**Attachment 2
NRC3-11-0002**

Markup of Fermi 3 FSAR, Revision 2

Markup of Detroit Edison COLA
(following 11 pages)

Supplemental Response to RAI letter related to Fermi 3 ER

Figure 2.1-203 Fermi Property Boundary [EF3 COL 2.0-2-A]

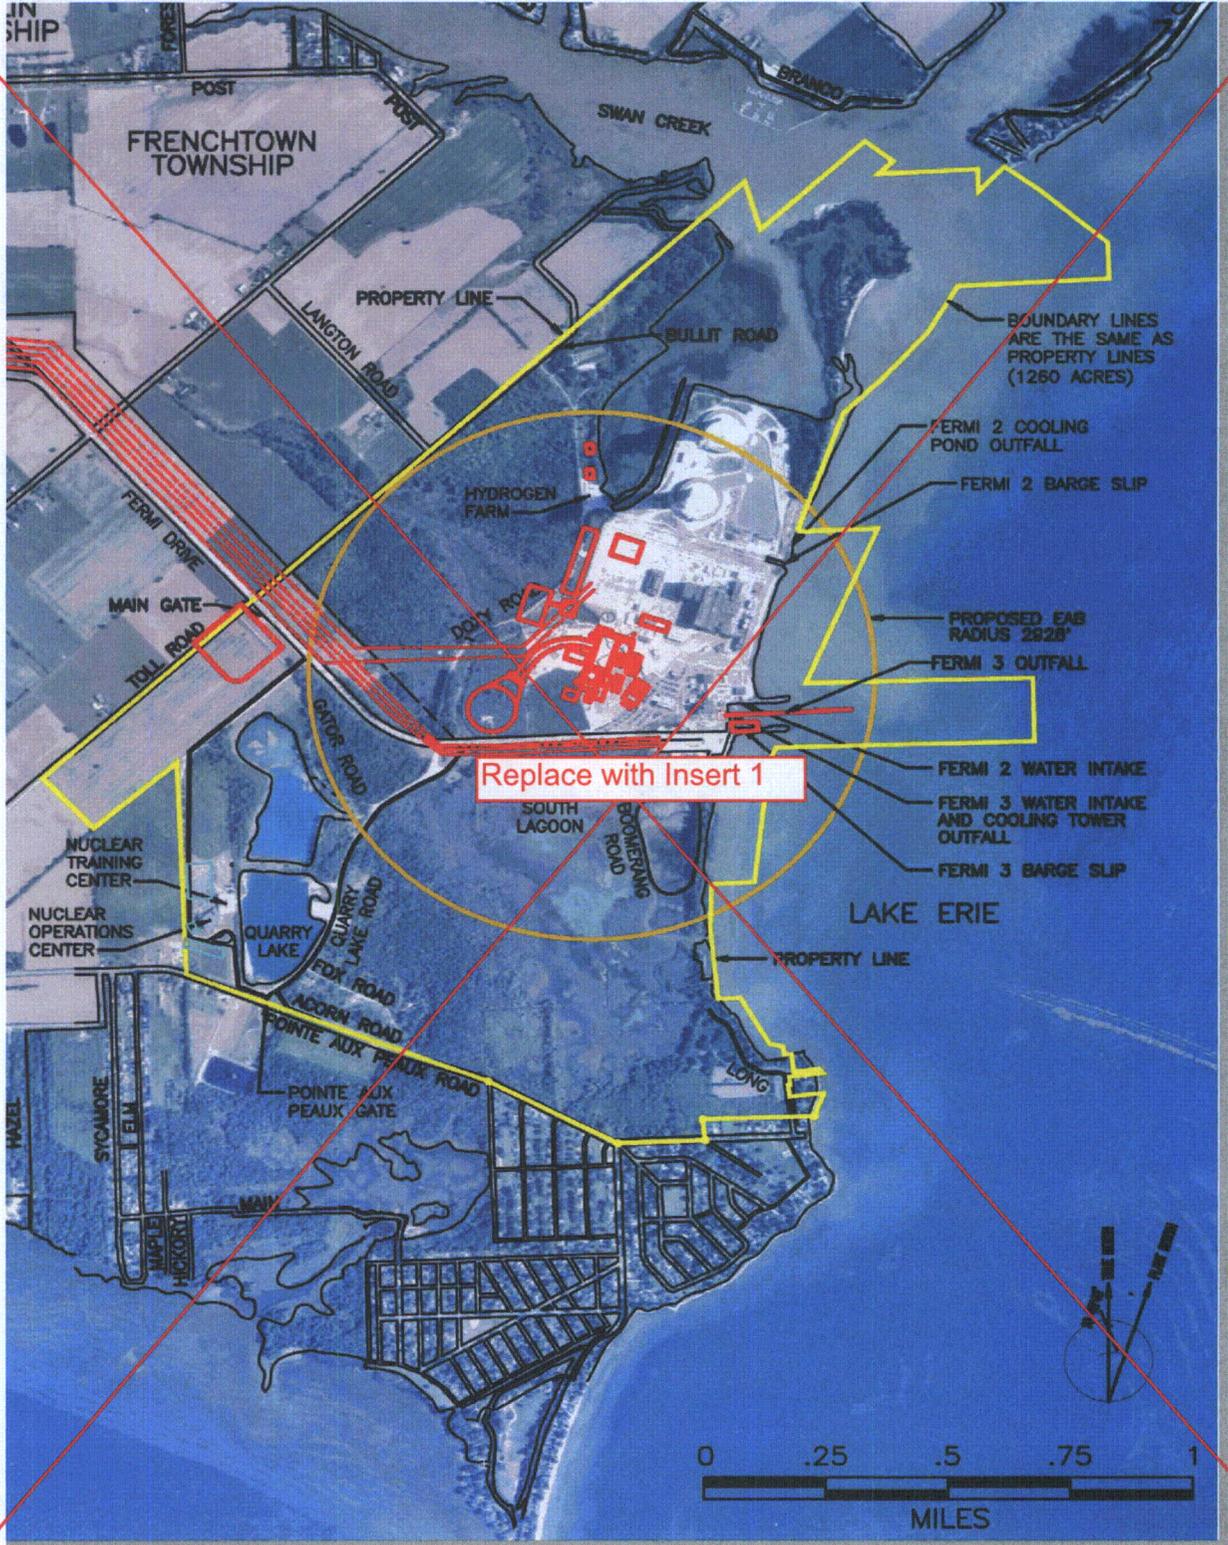
FSAR Markup	Description of FSAR Markup
Figure 2.1-203	Revised to reflect changes to the on-site transmission.
Figure 2.1-204	Revised to reflect changes to the on-site transmission and the meteorological tower location. Removed "Eagle Nesting Area" pointers, as these are not relevant to the FSAR. Revised Facility Legend for Item #39 to indicate that this is the Fermi 2 ISFSI.
Section 2.3.2.2	Revised to reflect new distances from the new meteorological tower location to the Fermi 3 Reactor Building, Natural Draft Cooling Tower, and the nearby water tower.
Section 2.3.3.3.1	Revised to reflect new distances from the new meteorological tower location to the Fermi 3 Reactor Building, Natural Draft Cooling Tower, and the nearby water tower.
Figure 2.4-211	Revised to reflect changes to the on-site transmission and the meteorological tower location. Removed "Eagle Nesting Area" pointers, as these are not relevant to the FSAR. Revised Facility Legend for Item #39 to indicate that this is the Fermi 2 ISFSI.

Insert 1 – Figure 2.1-203, Property Boundary

Figure 2.4-211 Fermi 3 Site Plan

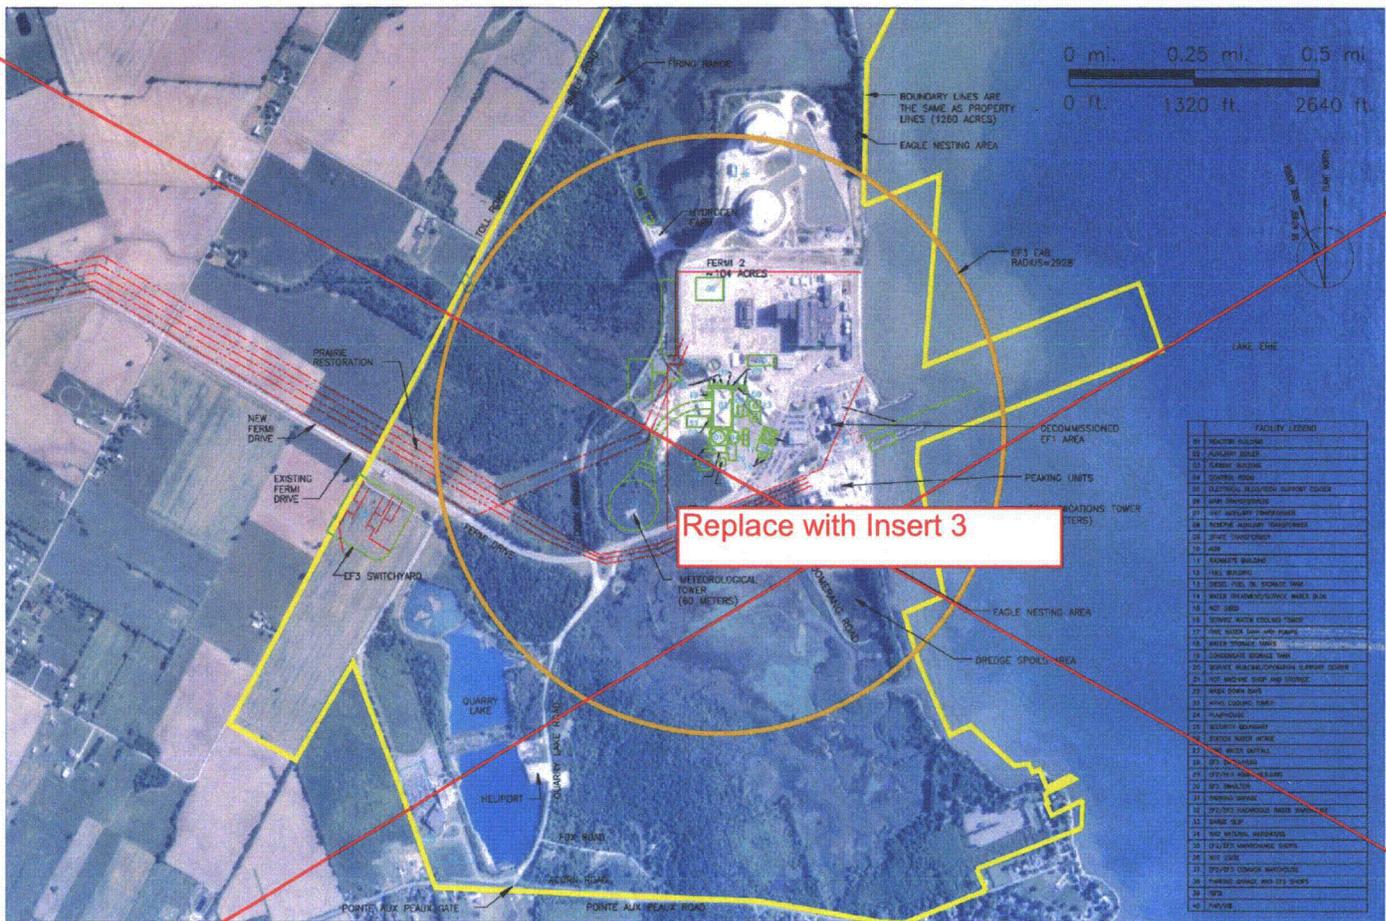
Replace with Insert 3

Insert 3 – Figure 2.4-211, Fermi 3 Site Plan

Figure 2.1-3 Fermi Property Boundary

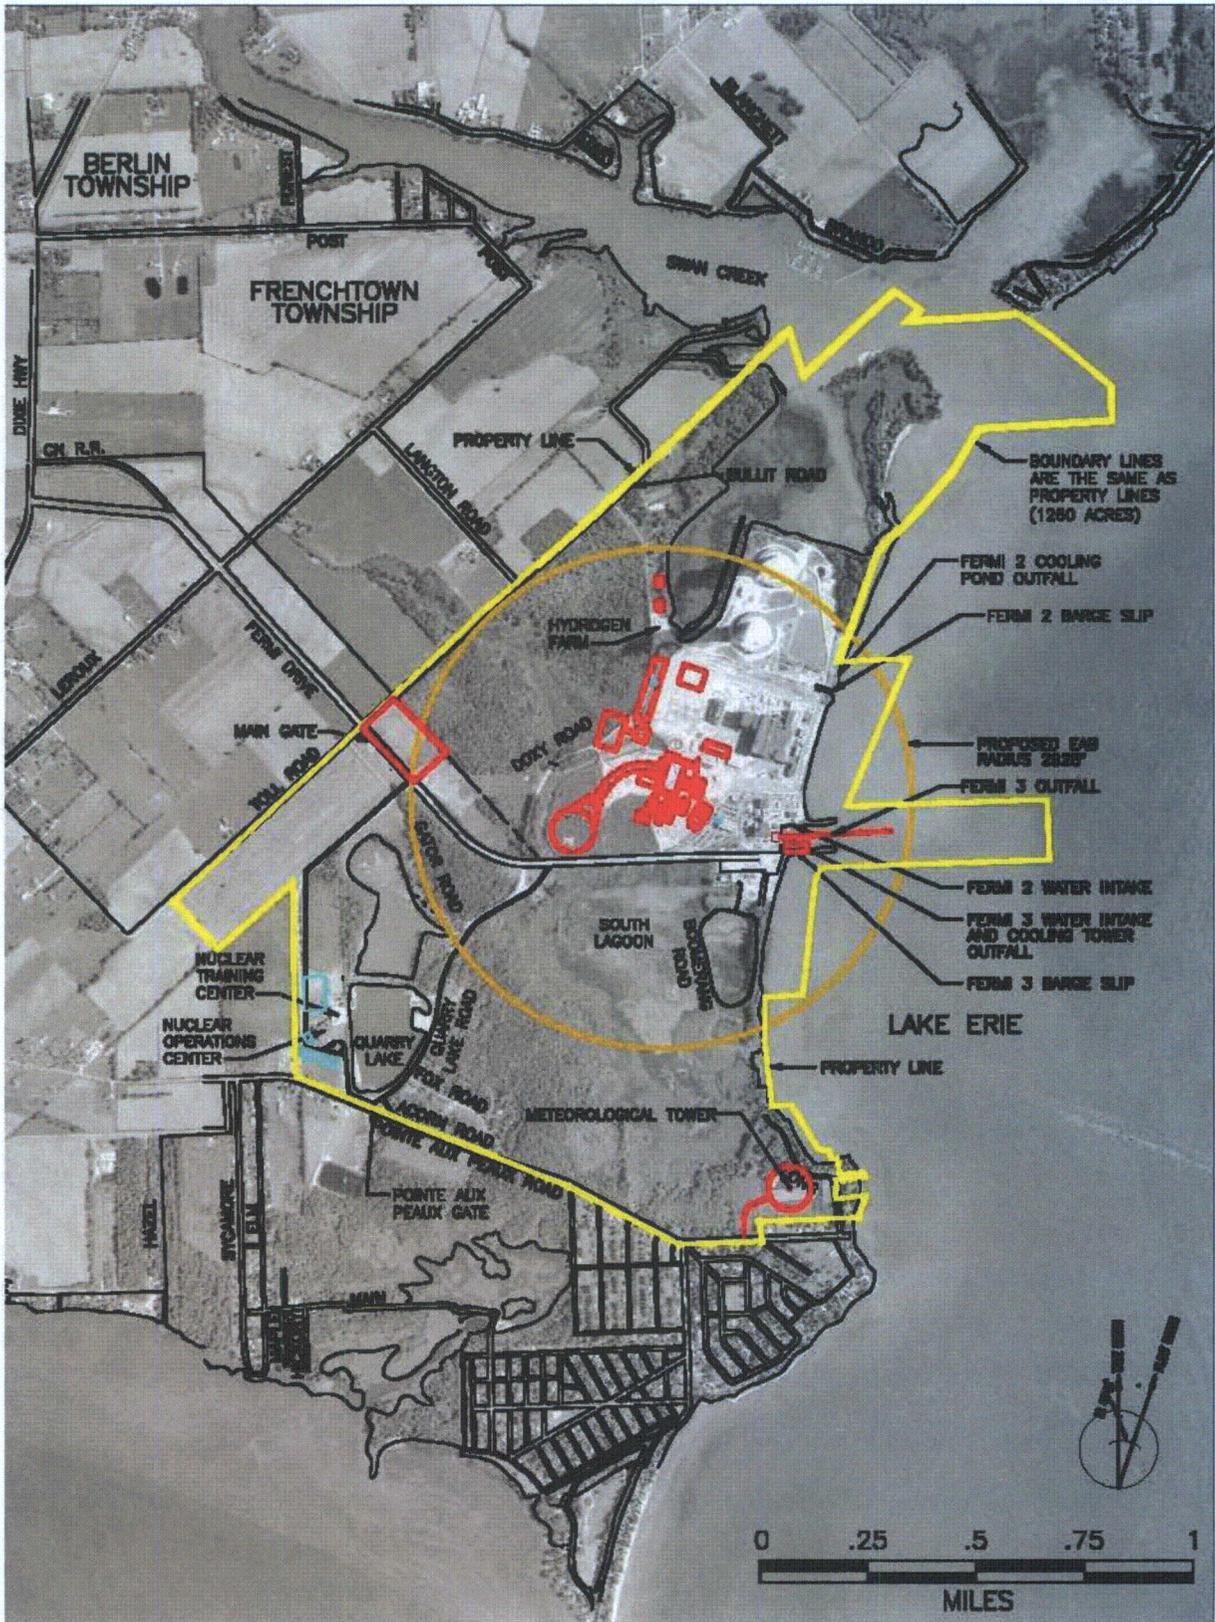
ER Markup	Description of ER Markup
Section 1.1.5	Revised to reflect the addition of the new onsite transmission corridor.
Figure 2.1-3	Revised to reflect new site layout.
Figure 2.1-4	Revised to reflect new site layout.
Section 2.2.1.1	Revised to reflect change to the farmland acreage, and revised to indicate that the switchyard will no longer be placed on agricultural land.
Section 2.2.1.2.1	Revised to clarify the private/public status of Toll Road.
Section 2.2.2	Revised to indicate that Section 3.7 only discusses the offsite transmission system, as the new site layout proposes the construction of an onsite transmission system.
Section 2.2.2.2	Revised to reflect the addition of the new onsite transmission corridor. Revised to reflect the location change of the onsite switchyard.
Table 2.2-1	Revised to reflect changes to land-use acreage.
Section 2.3	Revised to insert three new references.
Section 2.3.1	Revised to reflect change in Fermi 3 construction and operation total impact acreage due to the site layout revision.

Insert 2

Figure 2.4-17 T&E & Important Species Map: Transmission Corridor

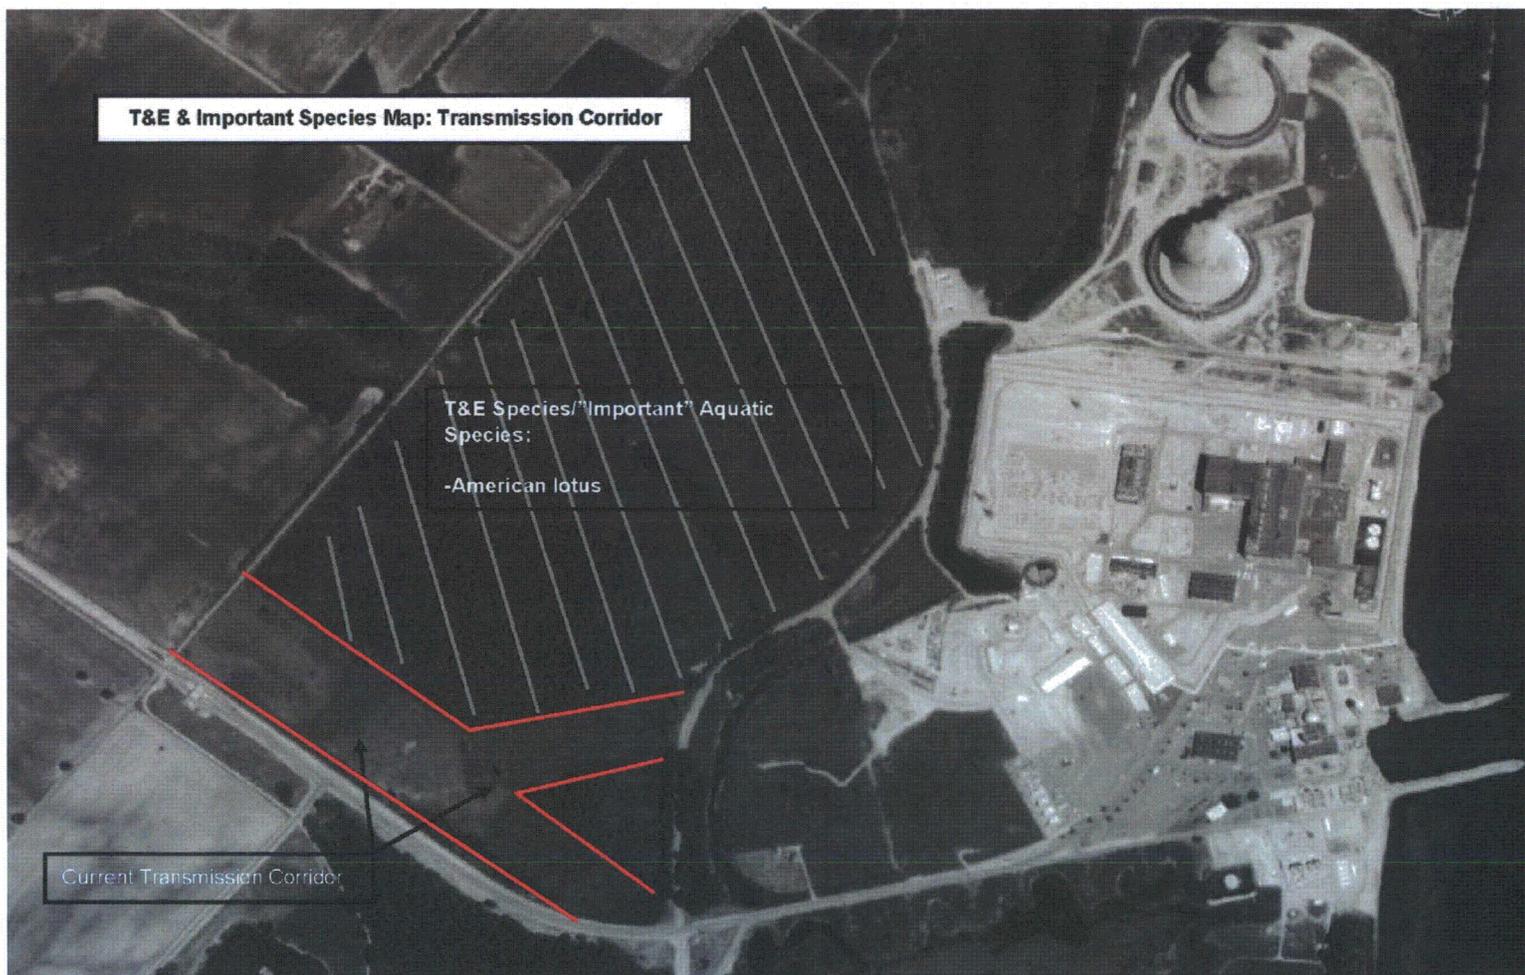
ER Markup	Description of ER Markup
Table 2.4-1	Revised to reflect changes to land-use acreages.
Figure 2.4-17	Revised to clarify that the figure represents the current onsite transmission corridor.
Figure 2.4-19	Revised figure of the Fermi site wetlands delineation to reflect latest information regarding onsite wetlands.
Section 2.5.3.2.1	Revised to update archaeological area of potential effect acreage due to increased size of the meteorological tower access road.
Section 2.5.3.2.2	Revised to update discussion of archaeological activities and their applicability due to site layout changes related to the meteorological tower.
Figure 2.5-27	Revised to reflect area of potential effect changes due to the site layout revision.
Figure 2.5-28	Revised to reflect area of potential effect changes due to the site layout revision.
Section 2.8.1	Revised to clarify that only the offsite transmission corridor is owned by ITC <i>Transmission</i> , as the new site layout proposes an onsite transmission corridor.

Figure 2.5-27 Fermi 3 Project Archaeological Area of Potential Effect

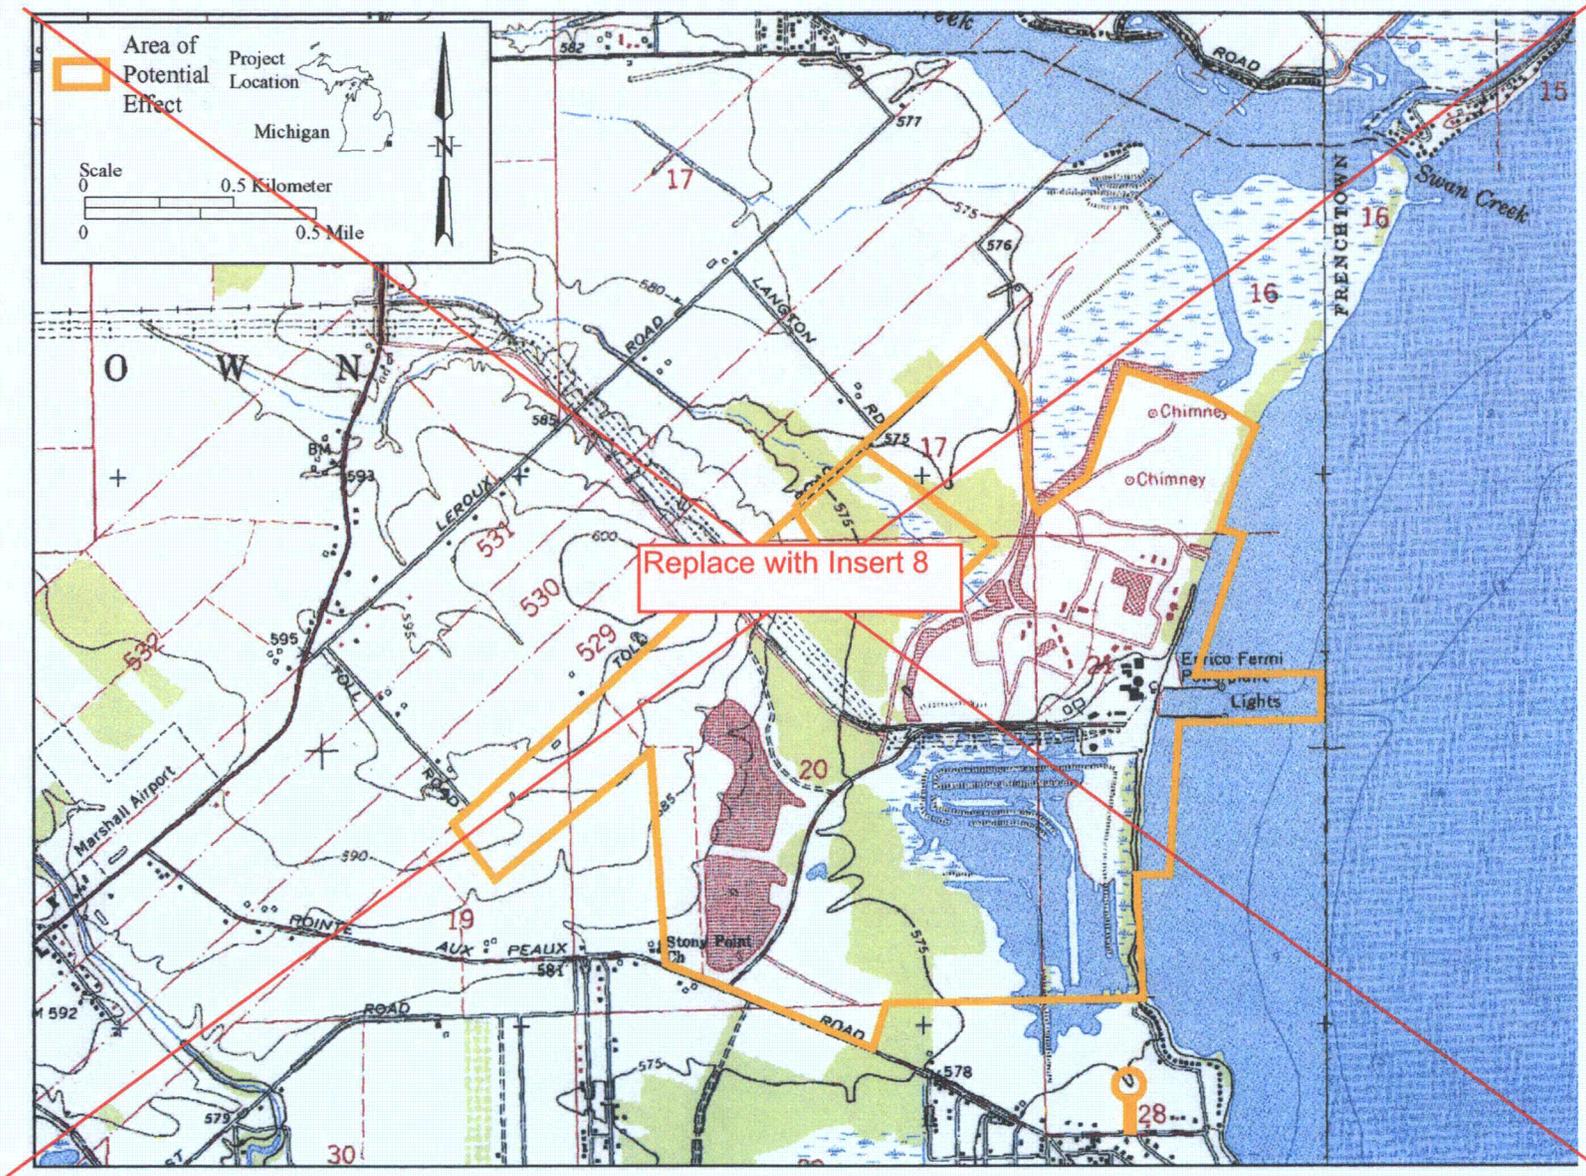
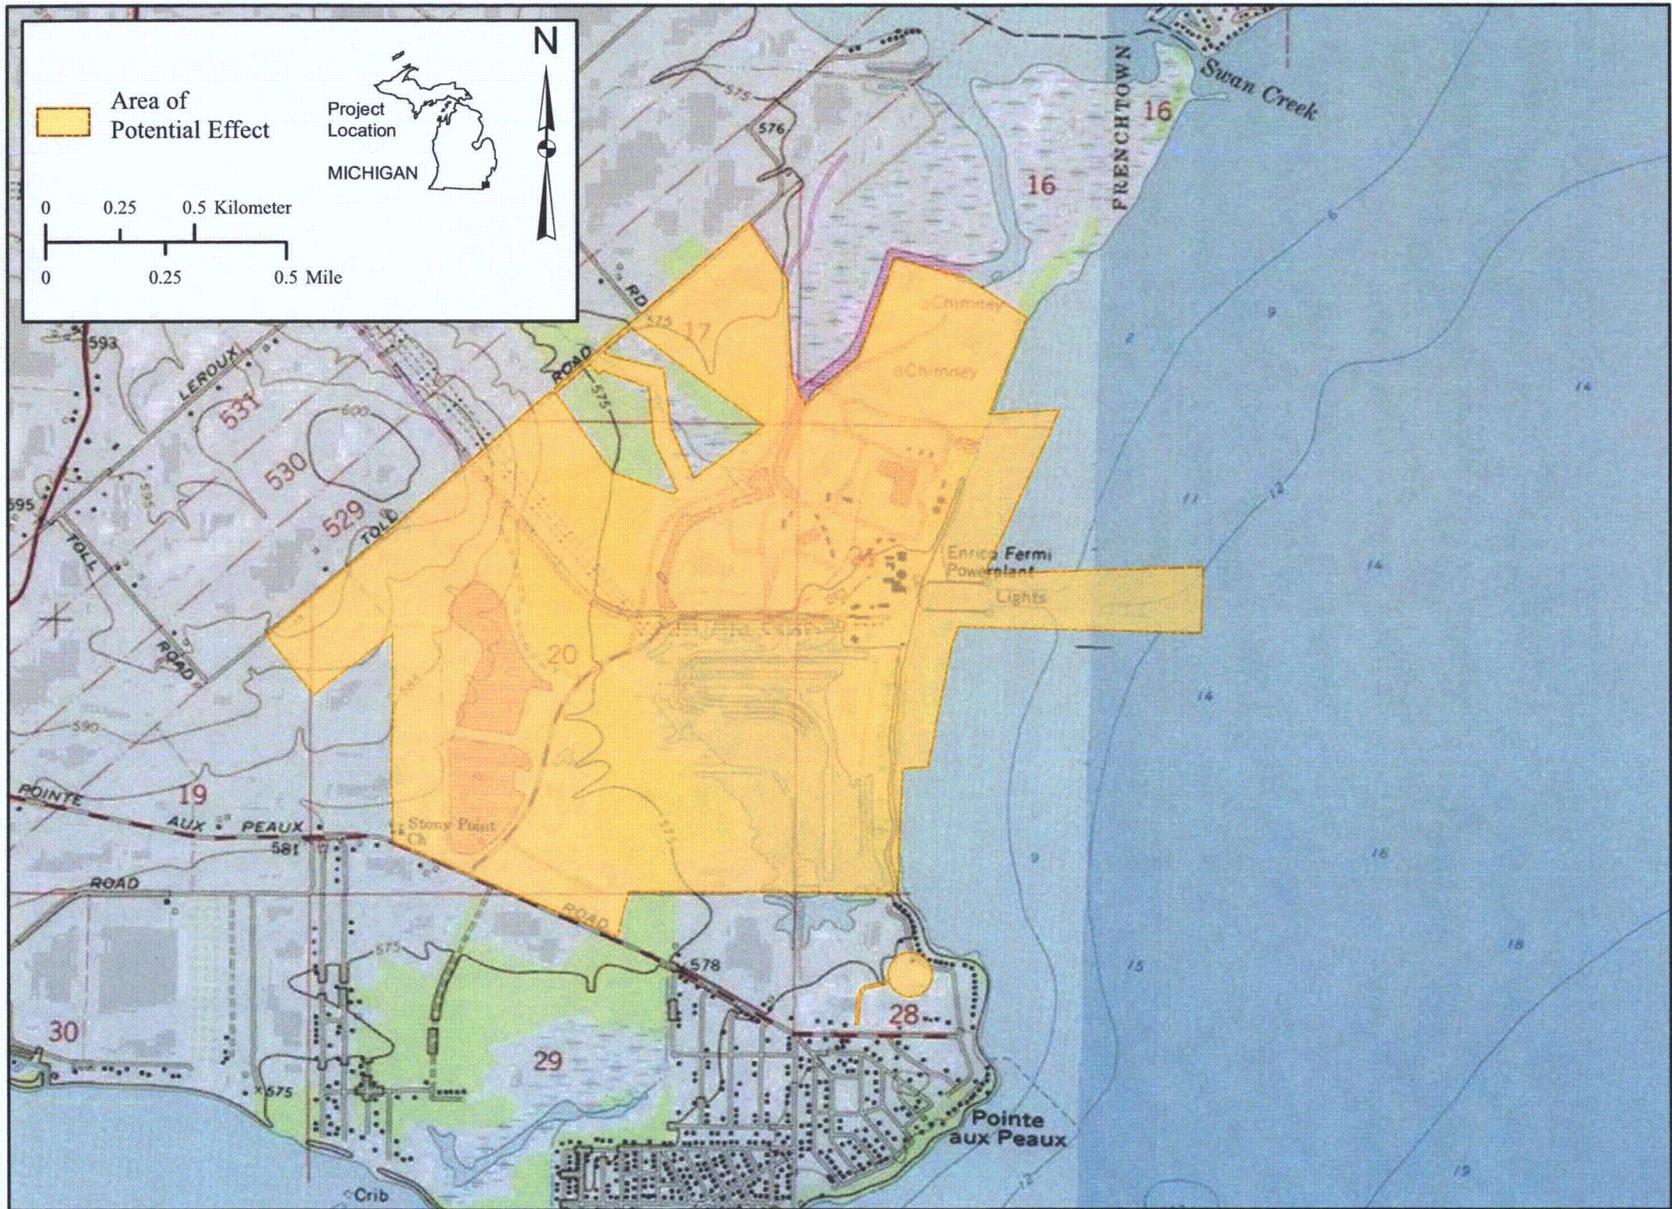
Insert 8 Figure 2.5-27
